Staff Report & Recommendation

Design Review Board

SUBJECT: DRB21-0738
291 Palm Avenue

An application has been filed requesting Design Review approval for the construction of a new two-story residence and the partial retention of an existing architecturally significant pre-1942 one-story residence on the west side of the property, including review of an understory, one or more waivers and variances from the maximum lot coverage and unit size, from the setback requirements (front, interior side & street side), from the maximum projection for allowable encroachments, from the open space requirements, from the understory requirements, and from the setback requirements for a roof deck, for the construction of new home, pool, and pool deck, to substantially replace an existing one-story architecturally significant pre-1942 residence.

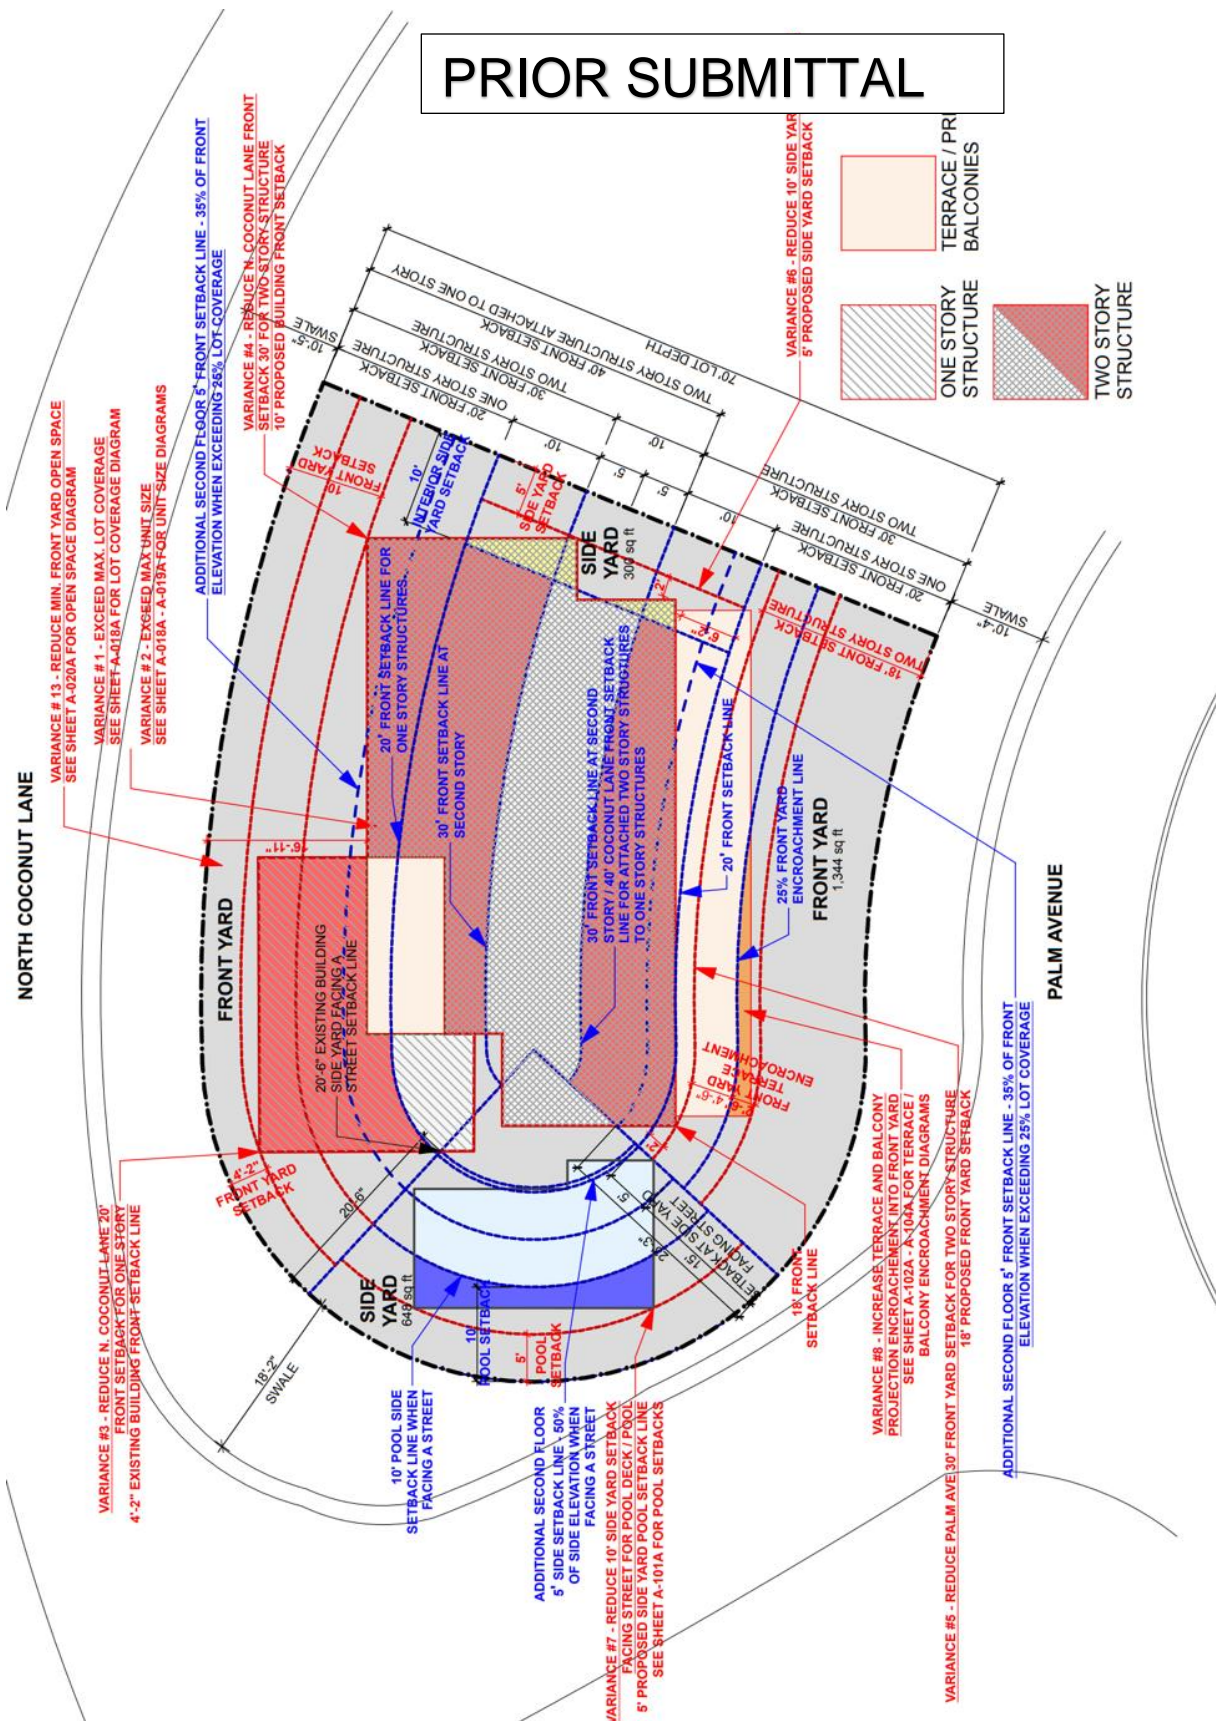
Due to the complexity and number of variances requested, staff has included below some of the variance diagrams provided with the application, as well as a rendering of the Palm Avenue frontage. The diagram below, from Sheet A-016 of the application, outlines the general setback requirements for the two single family lots resulting from the lot split application approved by the Planning Board on October 26, 2021. 'Lot A Revised' is the subject lot that is part of this application.

This lot is rather unique in that it not only has two fronts and a street facing side, but is also very shallow, with a lot depth of only 70 feet. Most single family lots on Miami Beach have a lot depth of at least 100 feet. The diagram below shows that absent any relief from the City code, with the current required setbacks, the maximum width of a single story home is only 30 feet, and the maximum width for a 2-story home is only 10 feet. This shallow lot depth, as well as the unique bean shape of the lot, does present a hardship for the construction of any home on the subject site.

Staff would also point out that the existing 2-story home (although much lower in height than the proposed new home) has a setback of around 5 feet for a large frontage of the home along North Coconut Lane. Again, based upon the hardship presented by the unique shape and depth of the lot, staff is supportive of the requested variances related to the primary setbacks of the home (**Variances #4 & #5**), including the proposed interior side setback (**Variance #6**) which maintains the minimum required setback from the street side yard.

The variance diagrams below, from Sheets A-013A and Sheets A-014A, outlines the majority of the requested variances(**Prior submittal diagrams provided for reference, along with current, revised diagrams**):

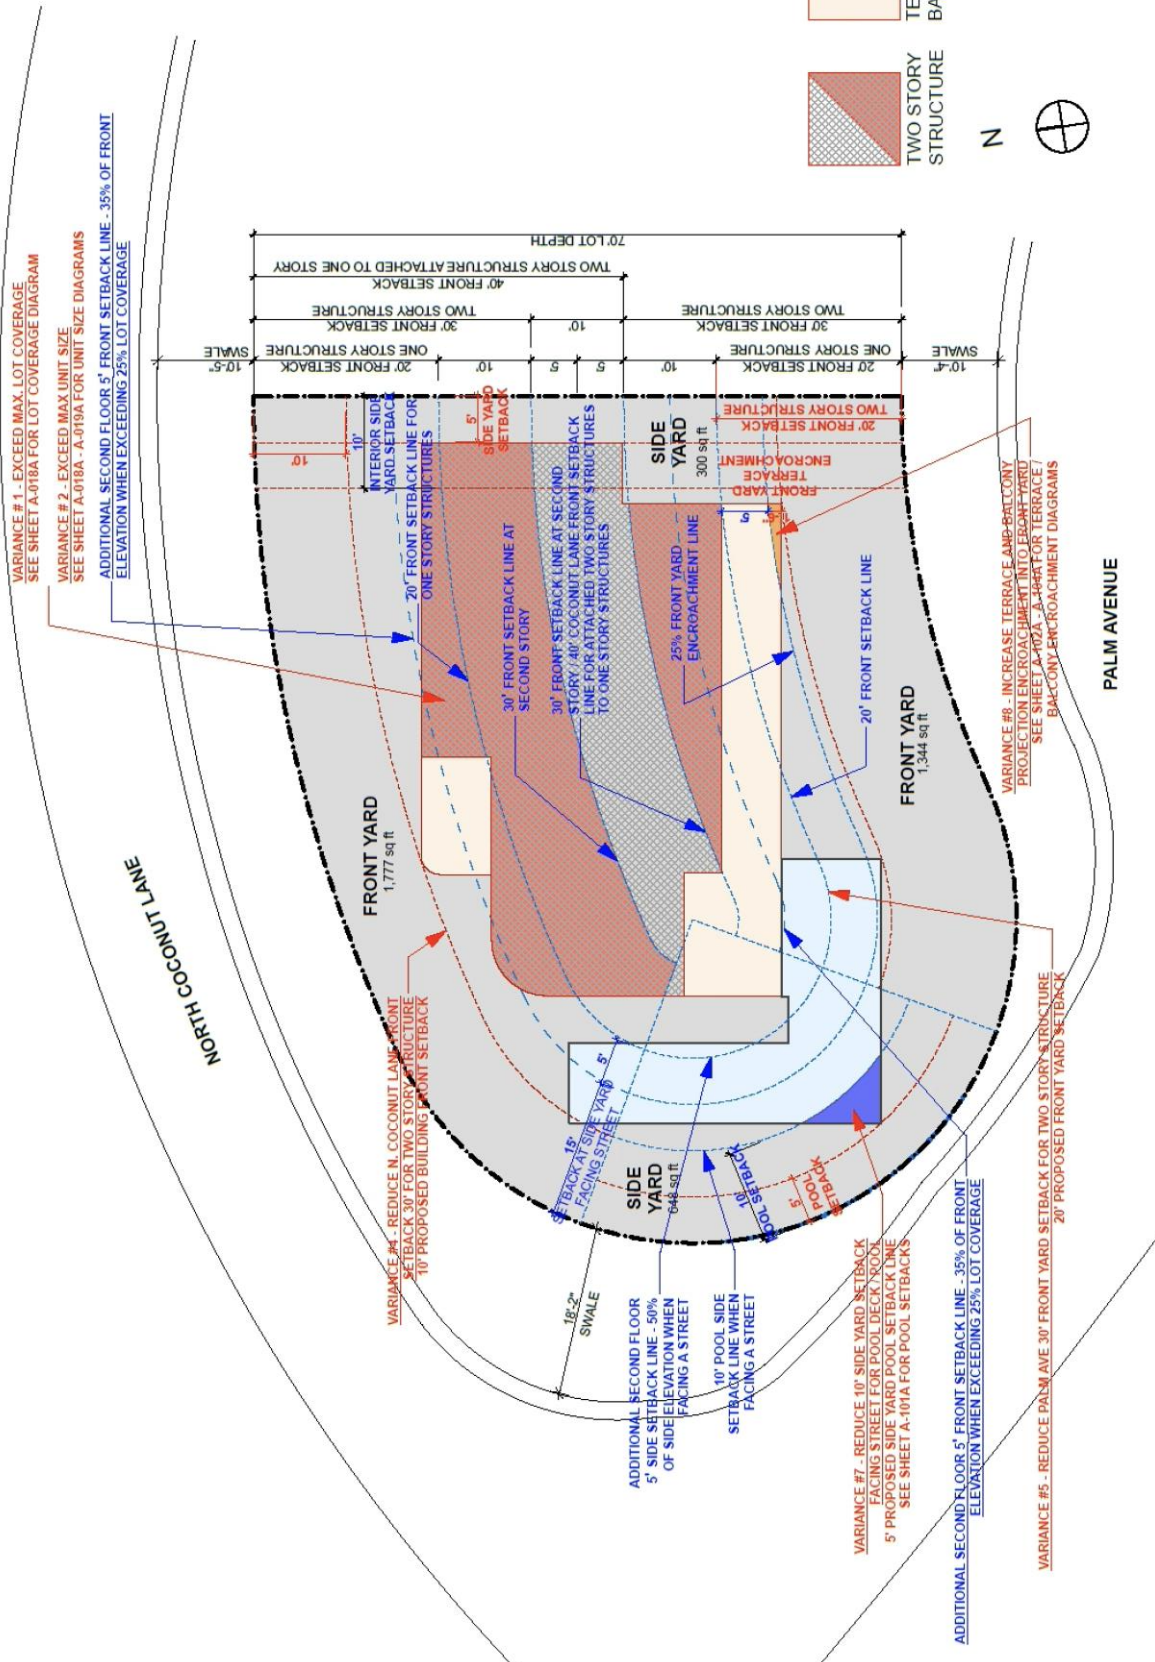
With the latest revisions to the plans, including the reduction in the proposed lot coverage and unit size, staff is supportive of the variances requested, as noted below, due to the unique shape and depth of the lot. The unit size has been reduced to 50% (from 54%) – **Variance #2**, and the lot coverage has been reduced from 33.5% to 27.9% - **Variance #1**. As noted previously, when a lot split includes the substantial demolition of a pre-1942 architecturally significant home, the maximum lot coverage is reduced to 25% and the maximum unit size is reduced to 40%. With the removal of the original single story garage structure, as recommended by the Board, **Variance #3**, for the elevation of the site has been withdrawn.

Due to the unique configuration of the lot, shallow lot depth, frontage on 2-sides, and a street facing side, the placement of a pool on the site also presents a practical difficulty for its construction. For these reasons, staff is supportive of **Variance # 7**.

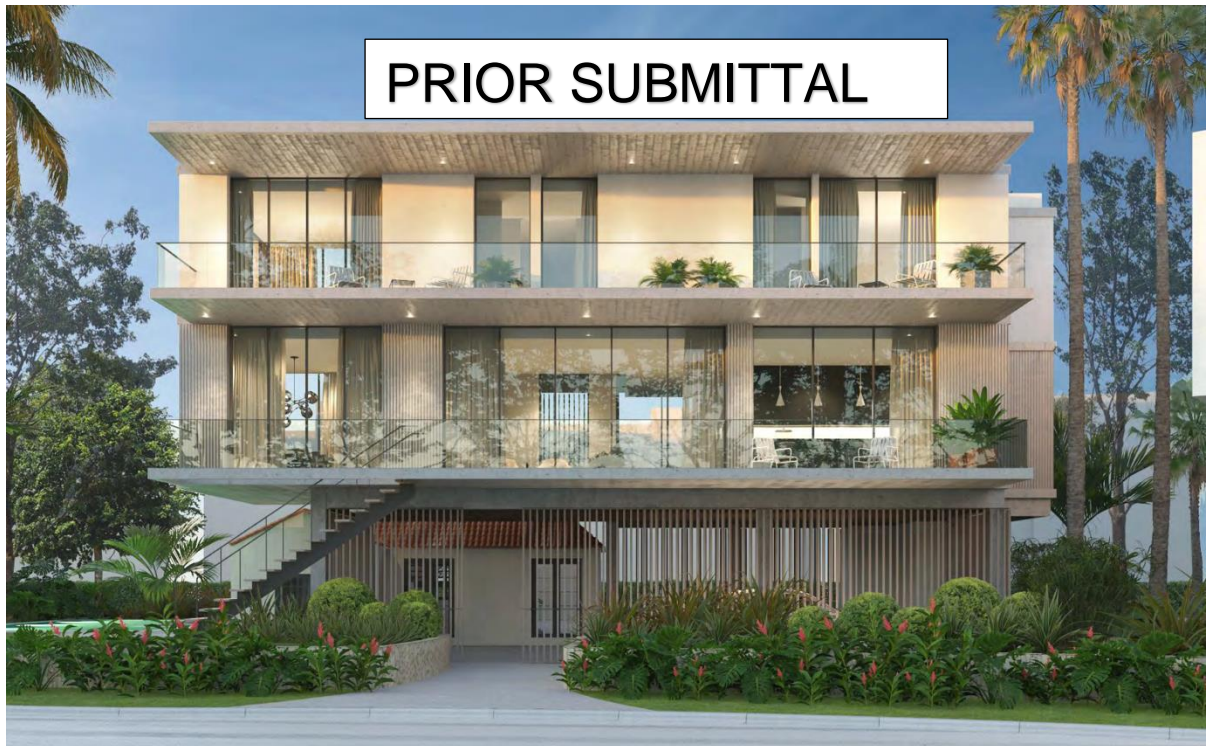
Regarding **Variance #8**, which is for balcony projections of 6'-6" feet facing Palm Avenue, where the maximum is 5'-0, the applicant has shifted the home, reducing the extent of the variance, which is now limited to a small area of the first level terrace and associated overhang at the southeast corner. The previously proposed balcony located above the southeast corner has also been removed, minimizing the variance request.

Due to the minimal depth of the home, as well as the shape and depth of the lot, both of which presents practical difficulties with designing a code compliant roof deck, staff is supportive of the requested setback variances for the roof deck (**Variance #9**).

MIN. ELEVATION FOR THE UNDERSTORY
ING OR RAISE TO 4.63 NGVD AS SHOWN
ON SHEET A-101A

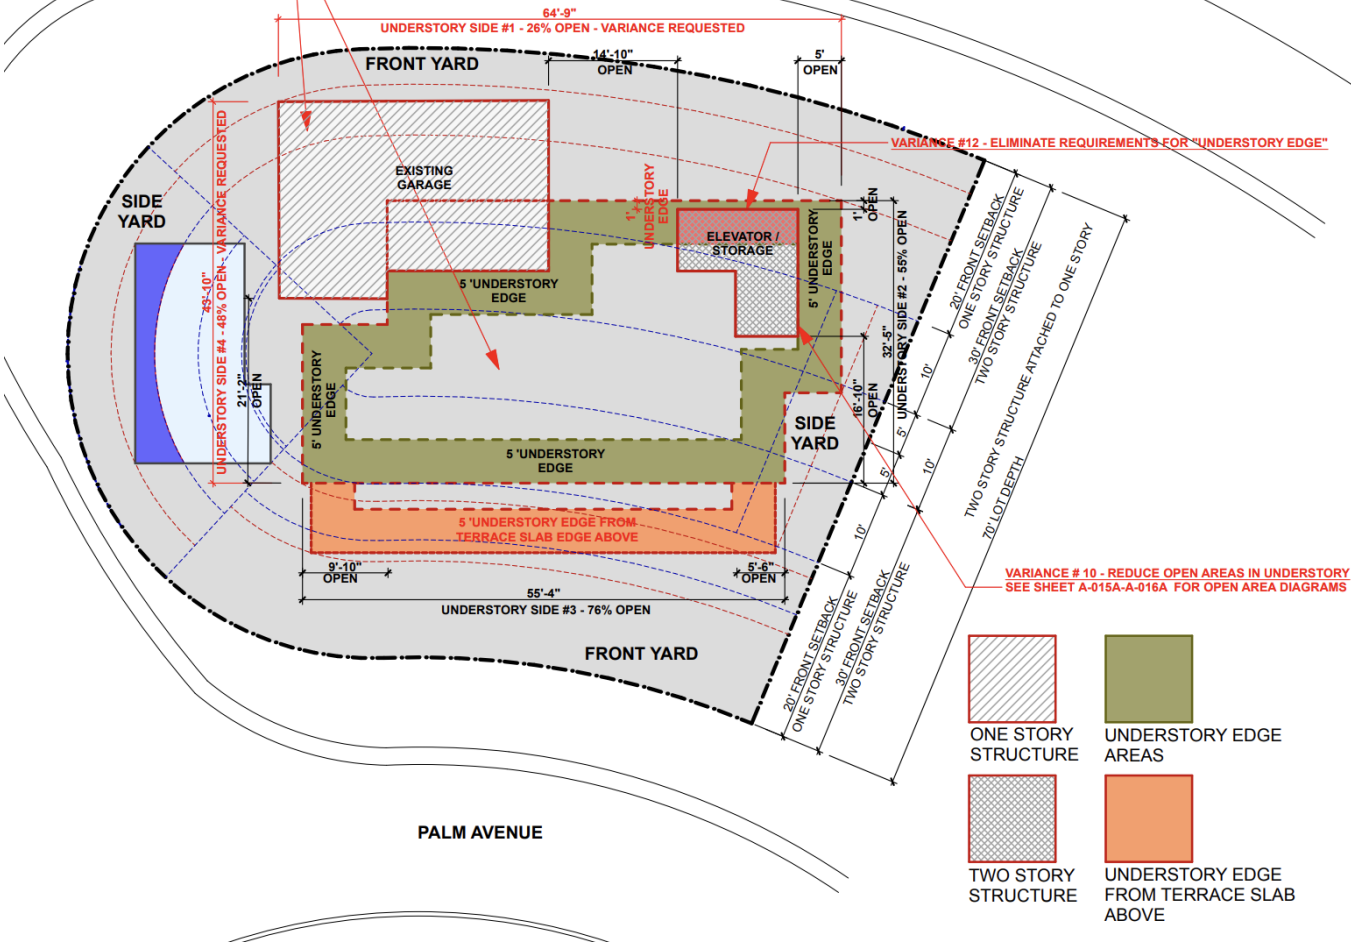
Variances 10-13 are all related to the understory requirements, as outlined in the below diagram from sheets A-014A from the application. Due to the hardship presented by the site, and practical difficulties previously noted, staff is supportive of these variances, as requested.
